ALS Corner Wiring Version 2

Addendum to LIGO-D1200666-v11

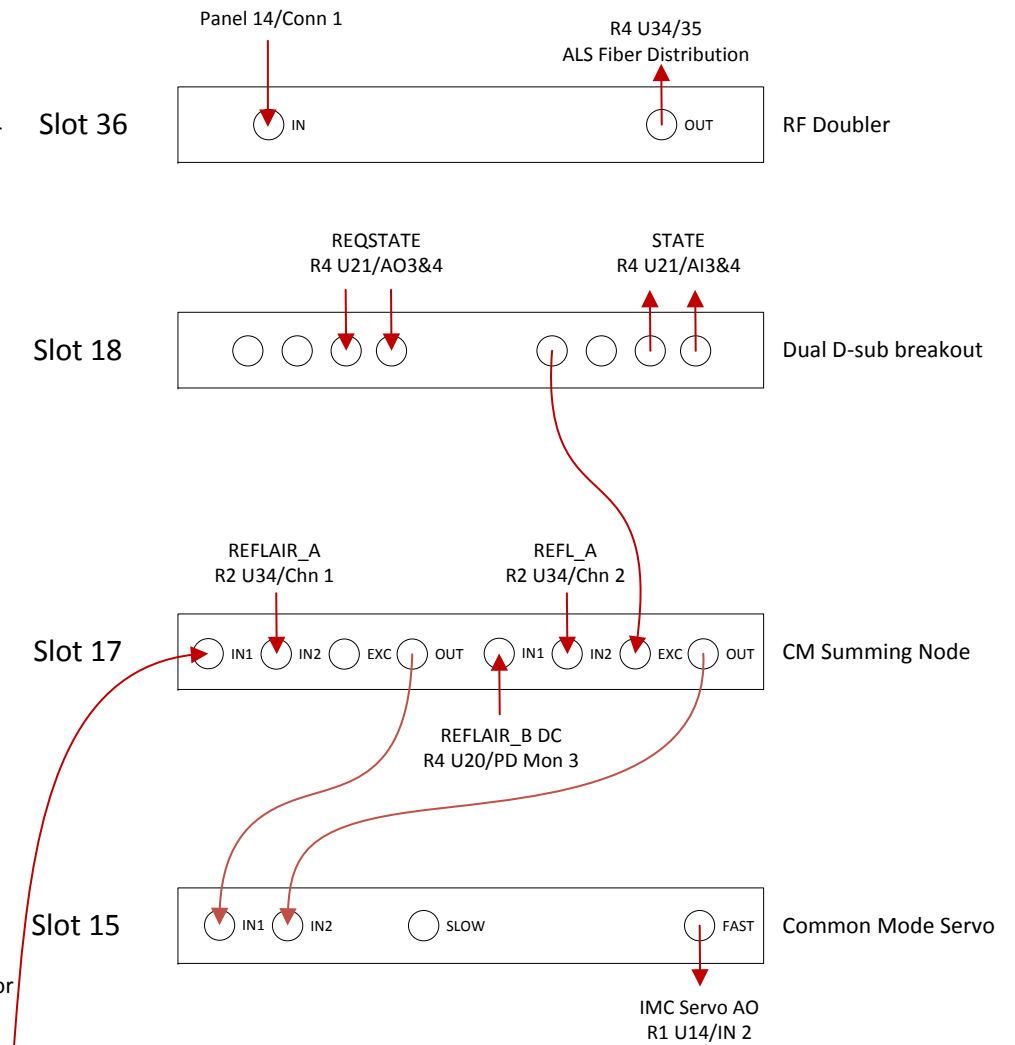
Changes:

- Move RF Doubler from R1/U18 to R4/U36
- Route RF cable through patch panel 4/1 (C4-U33) and 14/1 (R2-U39) with a balun on the R2 side. Previous panels were 1/2 (C4-U39) and 10/2 (R1-39).
- Move DB25 cable in the rear with the RF Doubler.
